PLANNING, ZONING, & BUILDING DEPARTMENT
 PZ&B Staff Memorandum: Architectural Commission

SUBJECT: ARC-24-0096 150 WORTH AVE

MEETING: FEBRUARY 26, 2025, ARCOM

ARC-24-0096 150 WORTH AVE—THE ESPLANADE. The applicant, Wilson 150 Worth LLC, has filed an application requesting Architectural Commission review and approval for updated paving, updated railings, removal of the main central staircase, and the addition of a water feature for the Esplanade.

Decorative Area Drain | 12” x 12” Interlaken Iron Age Grate Cover

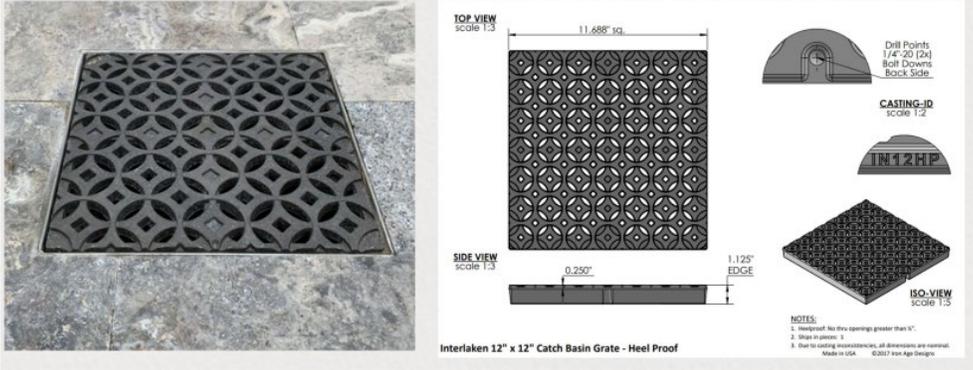
Drainage will be addressed with a 12”x12” grate cover:

This product is ADA Compliant and has been reviewed by plumbing engineer to meet water flow requirements.

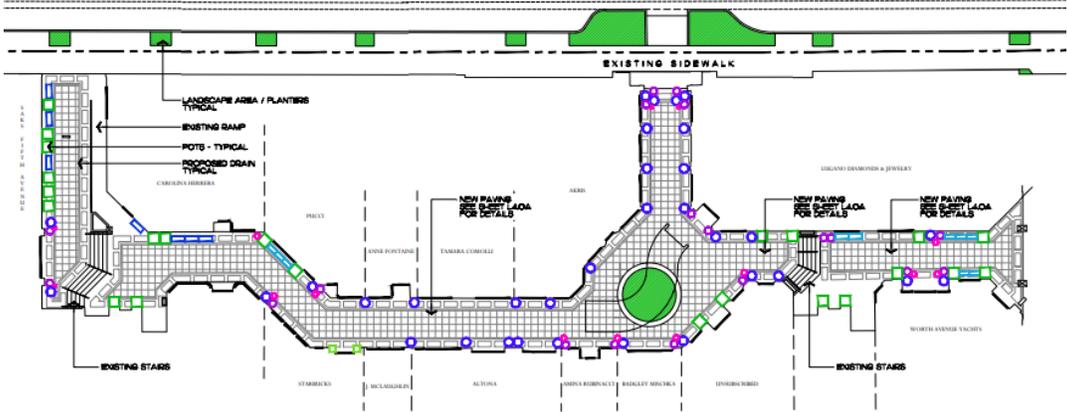
The next most visible change will be tiles on the stair risers proposed as such:
